PIVOT ARCHITECTURE

ADDENDUM # 5

Project: **Klamath Community College Childcare Learning Center (2331.00)**

Date: September 4, 2025

1 M201 LEVEL 1 - HVAC PLAN
1/16" = 1'-0"

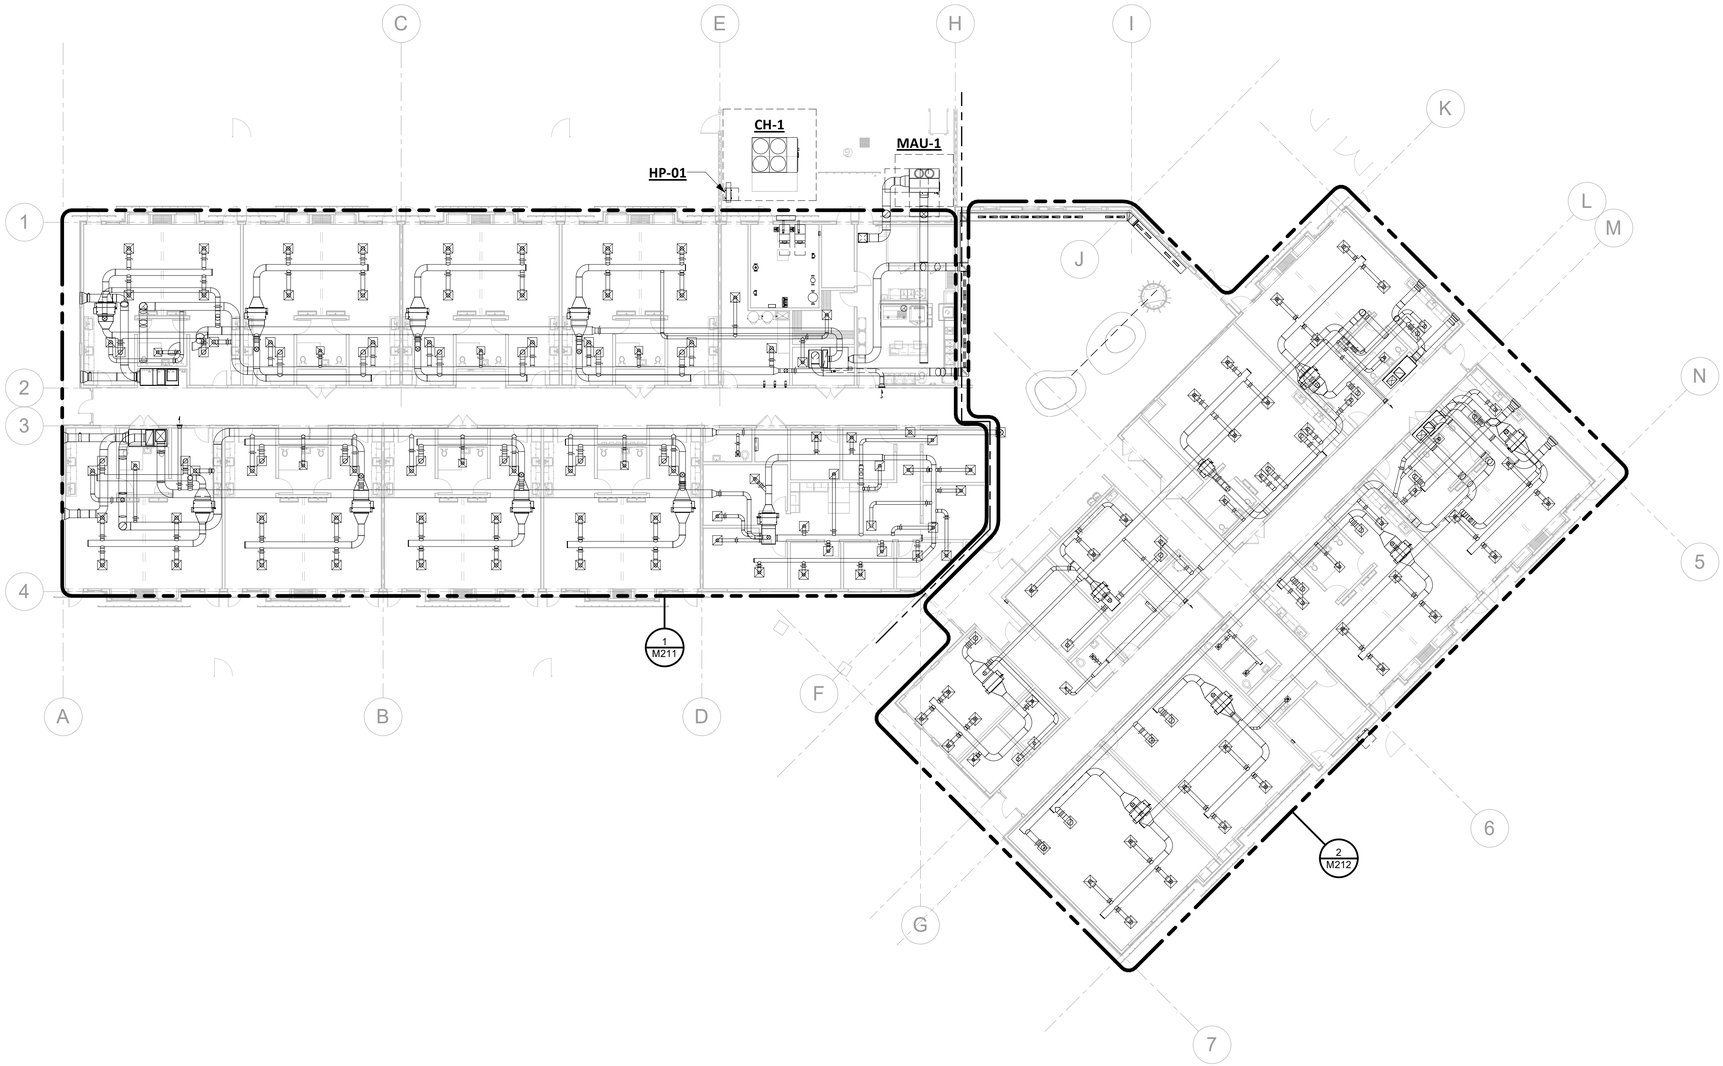
3.57. SHEET M201

3.57.1. – Plan updated with new duct routing and added enlarged view tags
